C & D Landfill
2 Landfill Rd
Happy Valley

17 December 2012

RE: Review of Slope Stability for Resource Consent, C & D Landfill, Happy Valley
Our Reference: 09870.000.000

Date	14/12/12	Client	C & D Landfill	
Drawn by	RJ	Project	Review of Landfill Slope Stability for Resource Consent	
Approved by	GC	Description	Plan View	
Scale	NTS	Figure No.	1	Project Number 09870.000.000

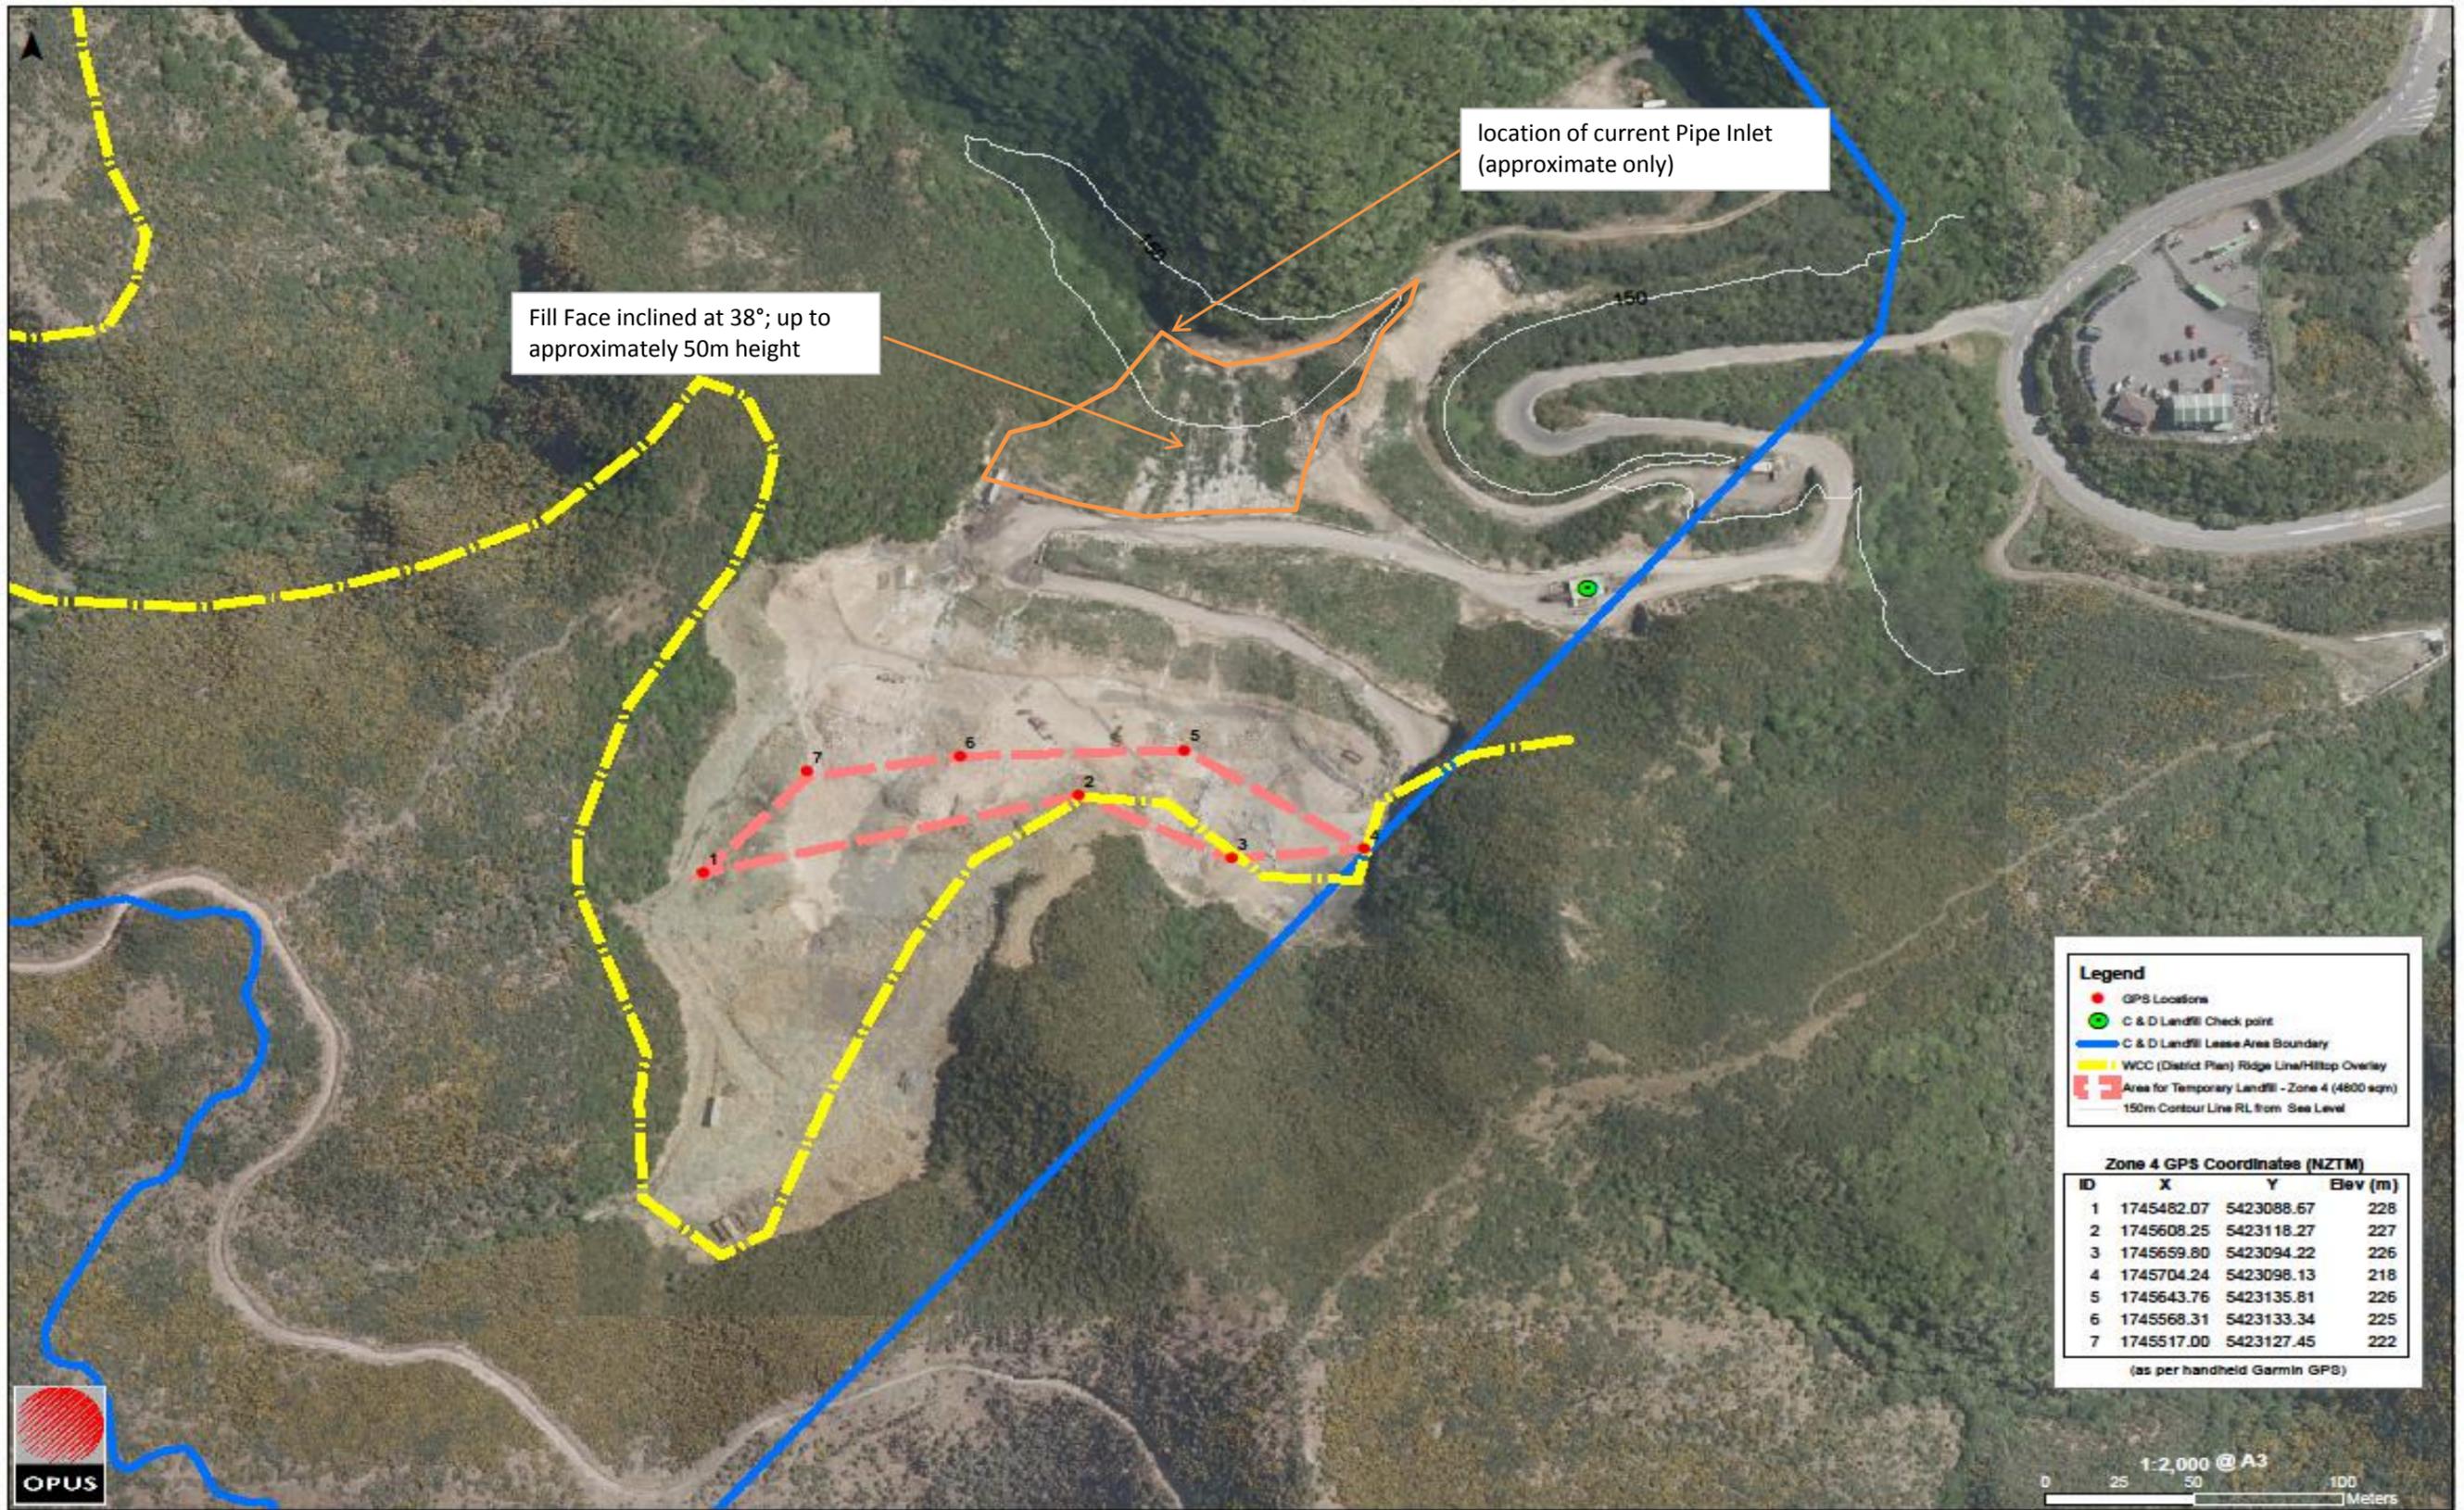
Aurecon further note that fill faces in 2009 were typically constructed at angles of around 1.2H: 1V to 1.3H: 1V (38° to 39°), and further note that these face may undergo localised failure under static (ie non-seismic) conditions. Whilst for the majority of the landfill, Aurecon did not consider this to pose a significant level of risk, concern was raised in regard the affect that this would have should failure occur on the high face above the culvert intake (Refer Figure 1, attached).

v) <i>Extension to main culvert up to the West Valley should have branch lines extending off the main at the junction with secondary valleys</i> <i>Each entry location... ..to have a proper permanent intake structure</i>	This recommendation should be adopted.	
vi) <i>.... Construction of a separate debris/trash screen some 10m upstream across the base of the gully to catch larger material...</i>	This recommendation should be adopted as shown on Figure 3	
viii) <i>Access tracks to the west valley may be achieved by use of the higher level fill benches....</i>	No comment – we consider this to be a design consideration; rather than a geotechnical consideration	
ix) This recommendation relates to infilling from the base of fill at the level of the culvert intake (132.5masl) to the 150m level. The recommendation discusses the requirement for a vertical manhole above the exiting culvert intake	We consider that filling should be undertaken up to a minimum level of 150masl as a matter of priority, and the culvert intake moved up valley to suit (Figure 2). We do not consider that a vertical manhole is required provided that adequate stormwater control is provided.	Infilling in the base of the valley and relocation of the culvert intake significantly reduces the risk of blockage due to slope failure within the area shown on Figure 1.

Date	14/12/12	Client	C & D Landfill	
Drawn by	RJ	Project	Review of Landfill Slope Stability for Resource Consent	
Approved by	GC	Description	Requirements for Fill Placement to 150masl	
Scale	NTS	Figure No.	2	Project Number 09870.000.000

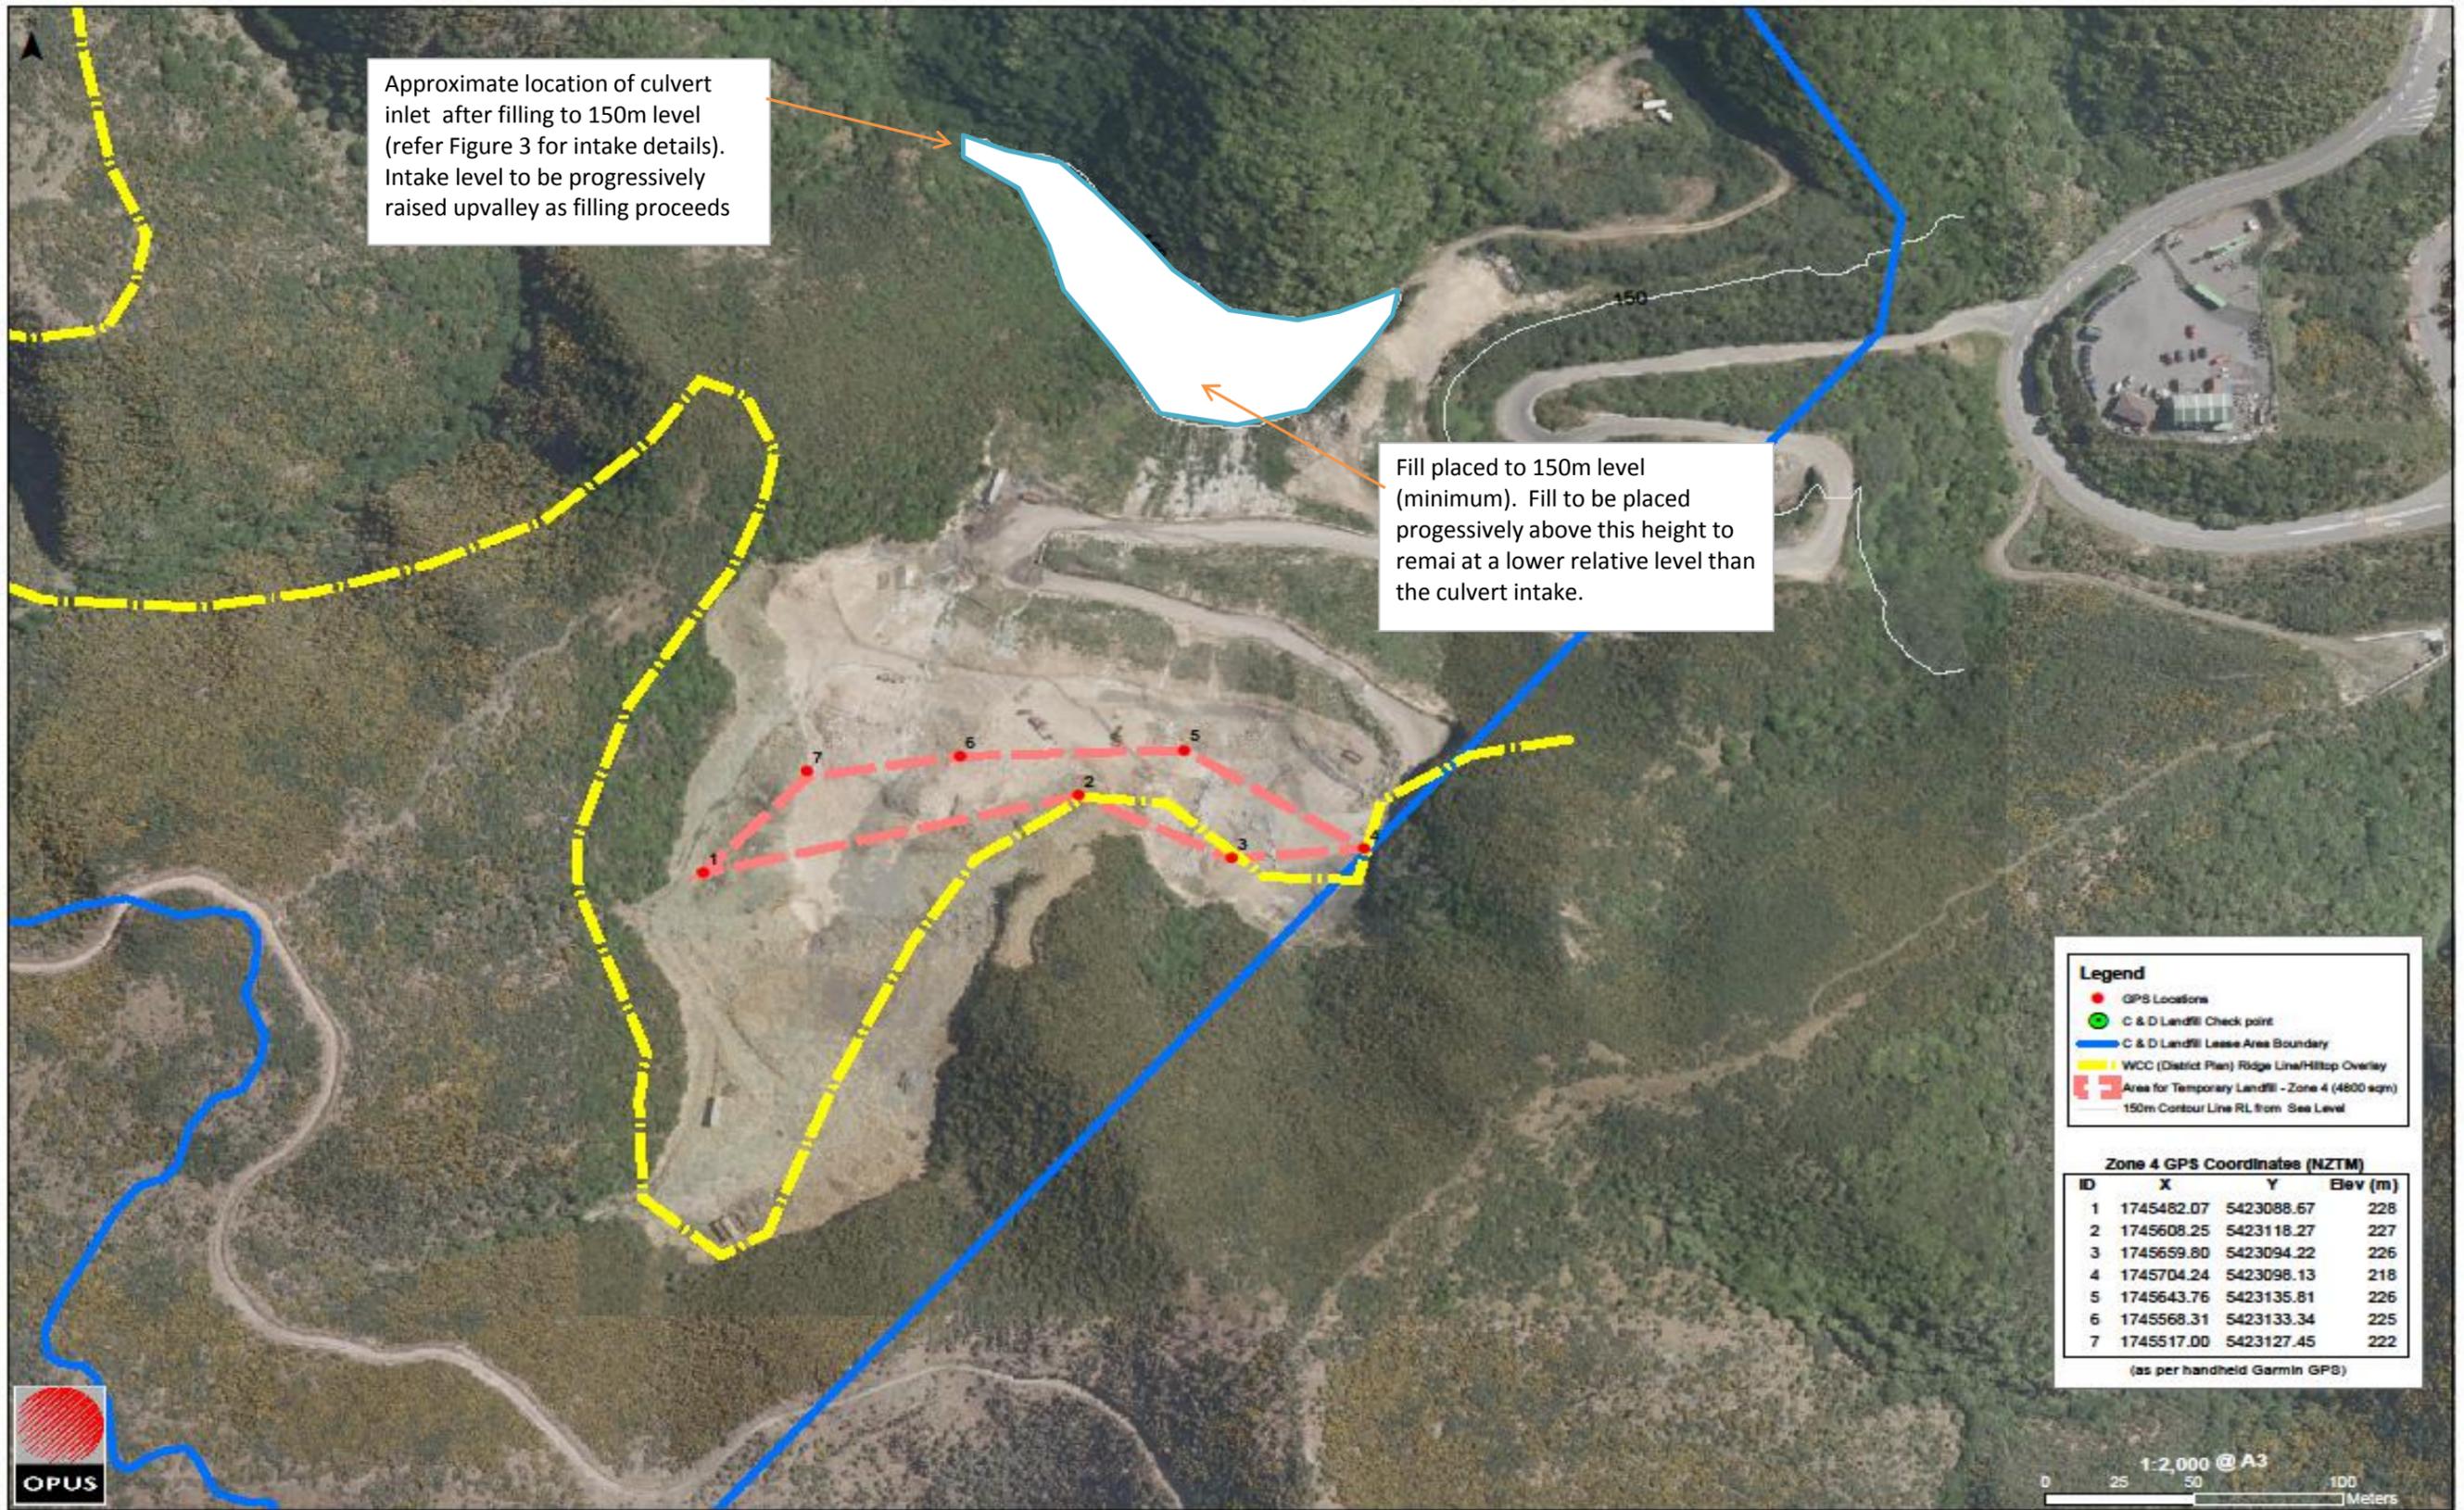
Approximate location of culvert inlet after filling to 150m level (refer Figure 3 for intake details). Intake level to be progressively raised upvalley as filling proceeds

Fill placed to 150m level (minimum). Fill to be placed progressively above this height to remain at a lower relative level than the culvert intake.
